ARC REVIEW CODE: R1803061

Name of Proposal: Gardner 42 (DRI 2775)

Development of Regional Impact (DRI) – Request for Comments

**GARDNER 42 DRI
Henry County
Natural Resources Group Review Comments**

DRI PLAN
SCANNELL PROPERTIES
LOCUST GROVE, GA
DRI #2775 - GARDNER 42 SITE, FEBRUARY 23, 2018

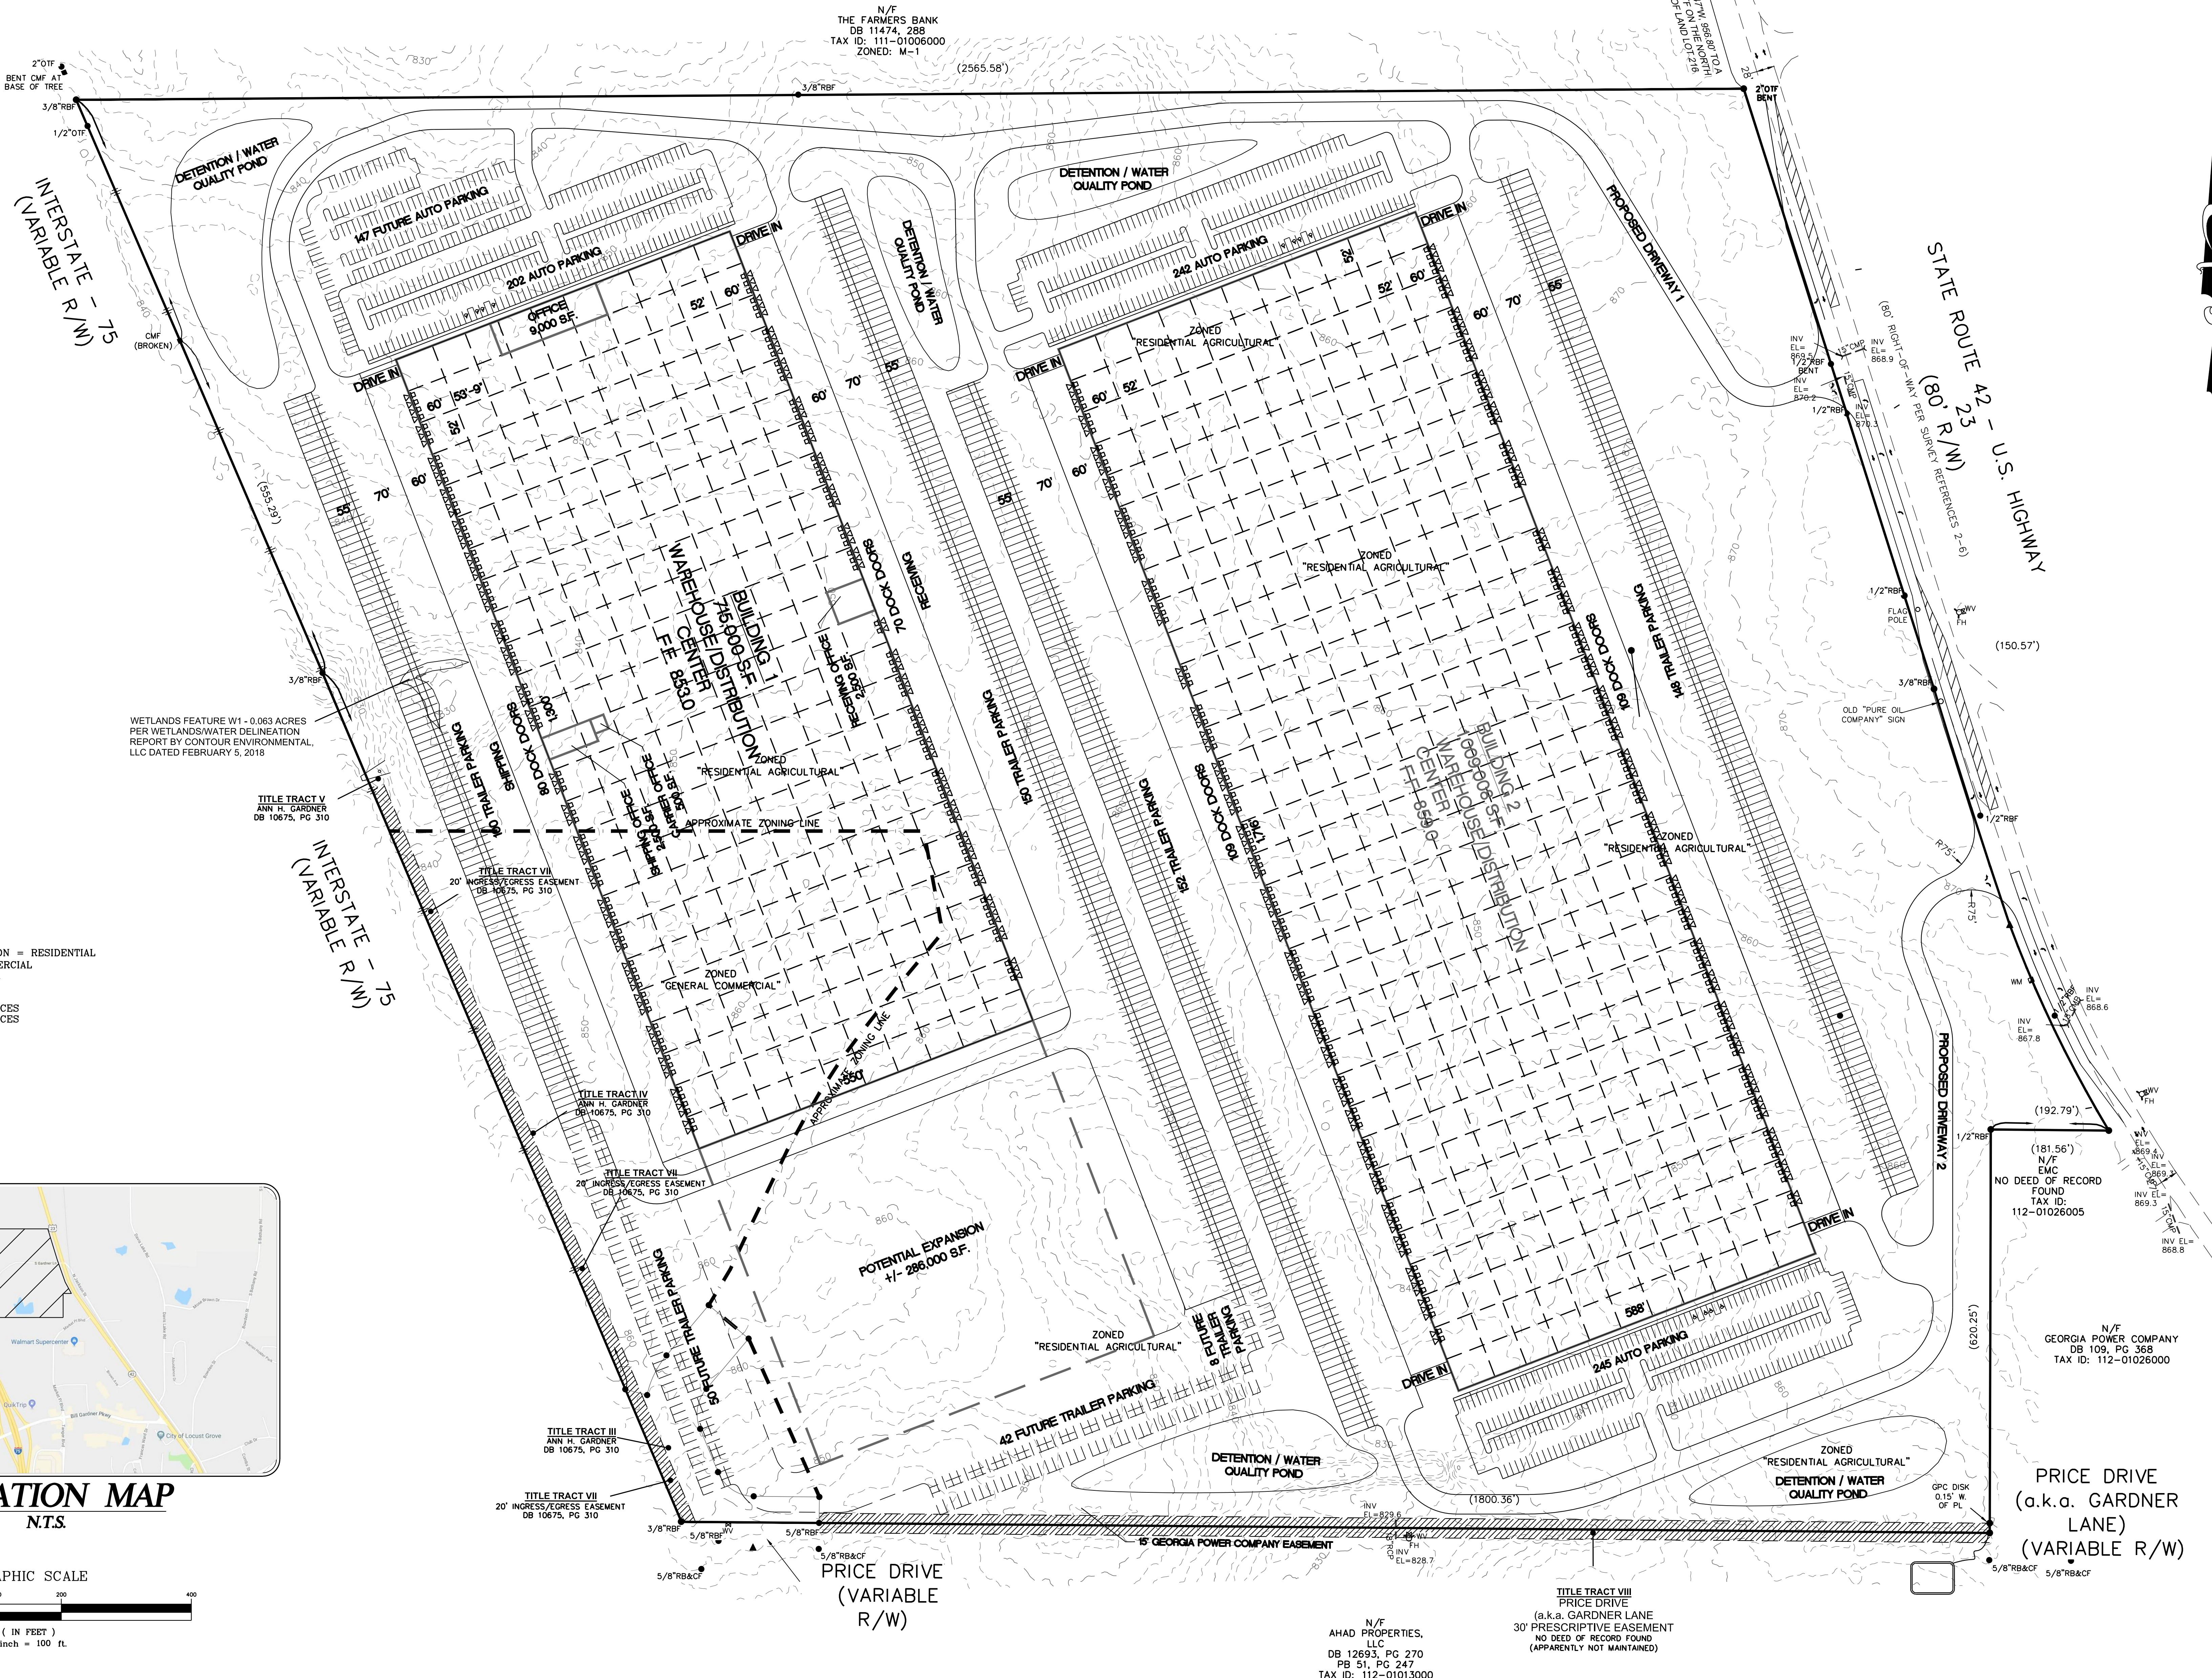
No stubouts are proposed. Vehicles will have to access adjacent parcel by SR 42.

The development doesn't propose internal or external sidewalk facilities.

The two driveways proposed allow for shared access and maneuvering of vehicle and freight traffic .

The development should consider constructing pedestrian facilities such as sidewalks on site frontage along SR 42.
